**CROSSROADS LANDFILL**

RE: Supplemental Information in Support of Phase 14 Solid Waste Permit Application  
License Application #S-010735-WD-YB-N  
Crossroads Landfill - Norridgewock, Maine

**RE: RESPONSE TO 9 SEPTEMBER 2020 MEDEP COMMENTS  
PHASE 14 SOLID WASTE PERMIT APPLICATION # S-010735-WD-YB-N  
CROSSROADS LANDFILL - NORRIDGEWOCK, MAINE**

Response to 9 September 2020 MEDEP Comments  
WMDSM Phase 14 Solid Waste Permit Application

PHASE 14 PROPOSED AREAS OF LINER SUBGRADE IMPROVEMENTS IN LOCATIONS WITH NO SOFT LOWER CLAY  
 WASTE MANAGEMENT DISPOSAL SERVICES OF MAINE, INC.  
 CROSSROADS LANDFILL  
 NORRIDGEWOCK, MAINE

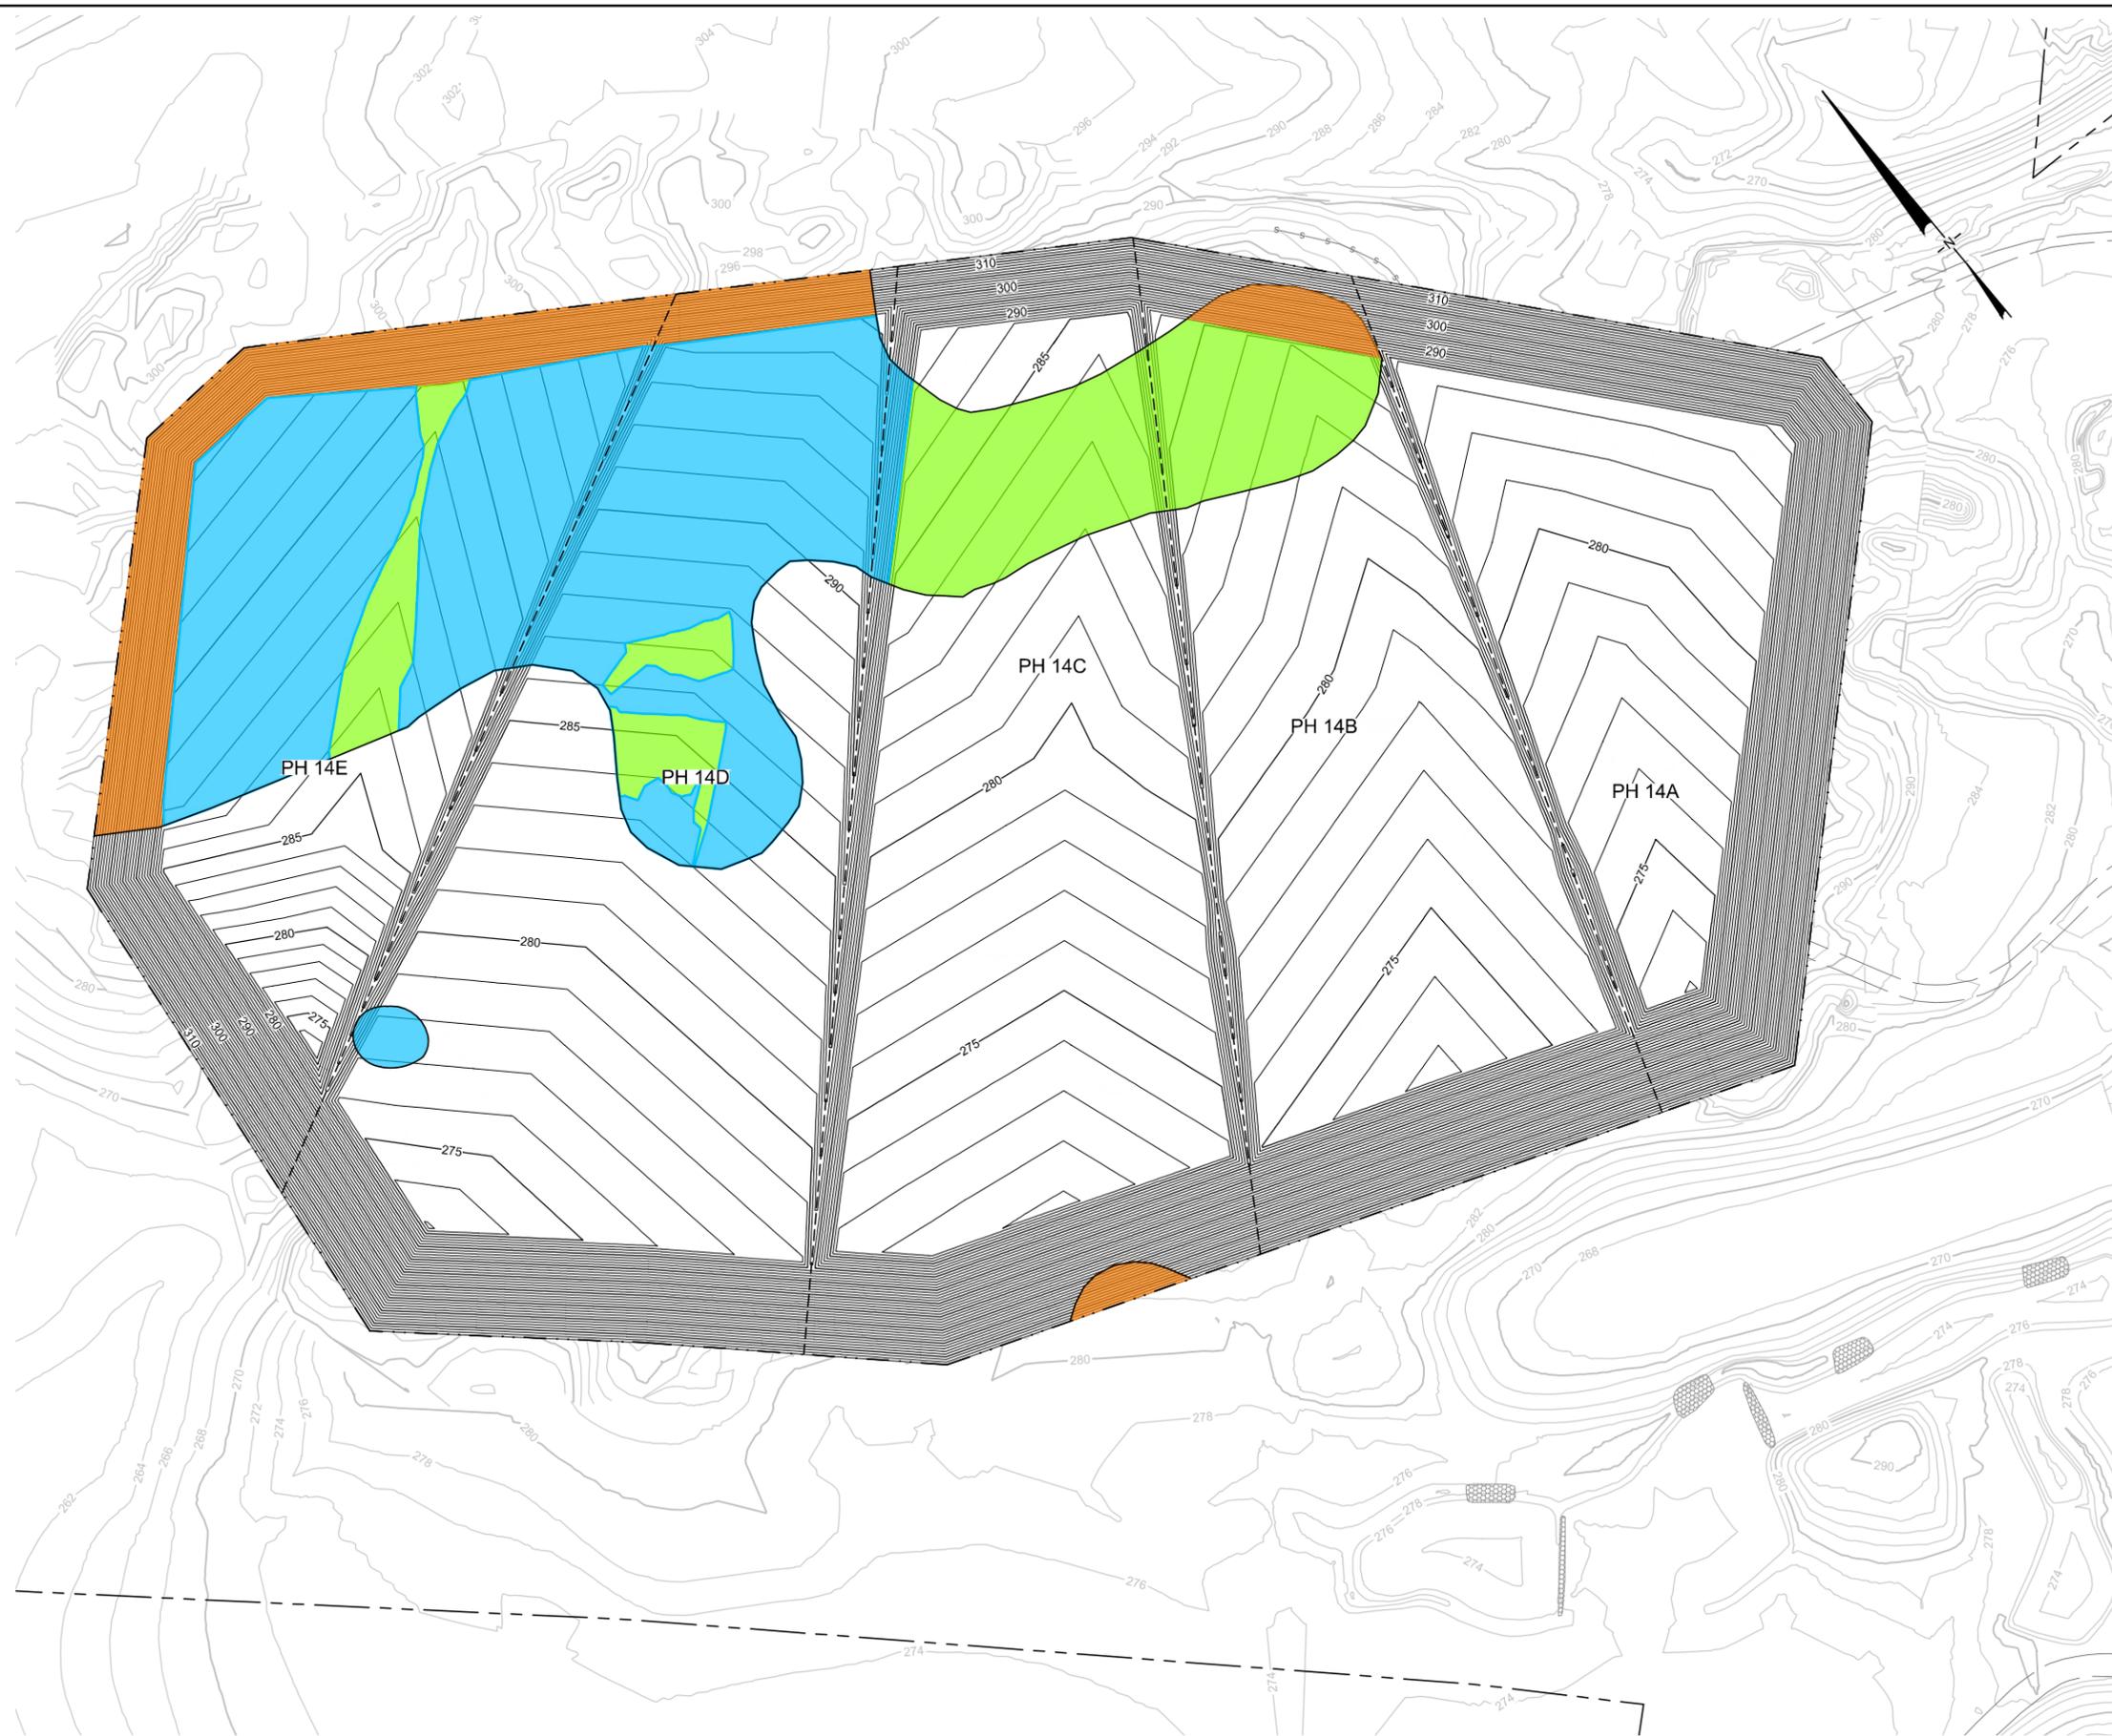
MEDEP has continued to express a concern that the bulk hydraulic conductivity of the stiff upper clay might be greater than  $1 \times 10^{-5}$  cm/s. In its 9 September 2020 review comments, MEDEP requested that WMDSM identify measures to address the areas where the Lower Soft Clay is absent and required WMDSM to submit a variance request to address the possibility that the in-situ undisturbed soils in those locations might not meet the minimum hydraulic conductivity requirement of Chapter 401.1C(3)(b). As discussed in responses to those review comments, WMDSM believes the evidence demonstrates that the requirement of Chapter 401.1C(3)(b) is met in all locations of the Phase 14 landfill. Nonetheless, to the extent that MEDEP concludes otherwise and as required, WMDSM is submitting this variance request in accordance with Chapter 400.13.C.

The areas shown on Figure 1 colored green designate where there is no Soft Lower Clay and where excavation to the liner subgrade elevation will terminate within the Stiff Upper Clay. The excavation surface in these areas will be scarified to a depth of approximately 8 inches and

Areas shown on Figure 1 colored blue designate where there is no Soft Lower Clay and where over-excavation will be performed to remove the eolian silty fine sand down to the surface of the Stiff Upper Clay. In these areas, the surface of the Stiff Upper Clay will be scarified prior to placement and compaction of silt-clay backfill up to the liner subgrade elevation. Compaction criteria for the clay backfill will be established by pre-construction Proctor testing and permeability testing of remolded specimens (likely targeted wet of optimum and to a density  $\geq 90\%$  of Proctor maximum dry density) to demonstrate the compacted silt-clay backfilled material has  $k \leq 1 \times 10^{-5}$  cm/s. Shelby tube samples will be taken at a frequency of 1 tube per acre from the uppermost lift (the top 8 inches) of the silt-clay backfill and sent to a geotechnical lab for permeameter testing for additional confirmation/documentation that the  $1 \times 10^{-5}$  cm/s criterion has been achieved. After the confirmation testing is complete demonstrating that  $1 \times 10^{-5}$  cm/s criterion has been achieved, the 1-ft thick  $1 \times 10^{-7}$  cm/s compacted clay component of the liner system will then be constructed directly on the compacted clay backfill.

Areas shown on Figure 1 colored orange designate areas under the liner sideslopes where there is no Soft Lower Clay and where the liner subgrade will terminate in the in-situ eolian silty fine sand slope excavation and/or where the sideslope will be created by the inner structural fill slope of the MSE berm. WMDSM will remove an extra 1 ft of the sand and place a 1-ft thick compacted silt-clay layer on the excavated portion of the sideslope and/or will leave the inner fill sideslope of the MSE berm 1 ft low and will place an extra 1-ft thick compacted silt-clay layer on that portion of the sideslope as well. Compaction criteria for extra silt-clay layer will be established based on pre-construction Proctor testing and permeability testing of remolded specimens (likely wet of optimum and to a density  $\geq 90\%$  of Proctor maximum dry density). Shelby tube samples will be taken at a frequency of 1 test per acre and sent to lab for permeameter testing for additional confirmation the  $1 \times 10^{-5}$  cm/s criterion has been achieved. After the confirmation testing is complete demonstrating that  $1 \times 10^{-5}$  cm/s criterion has been achieved, the 1-ft thick  $1 \times 10^{-7}$  cm/s compacted clay component of the liner system on the sideslope will then be constructed directly on the silt-clay subgrade layer.
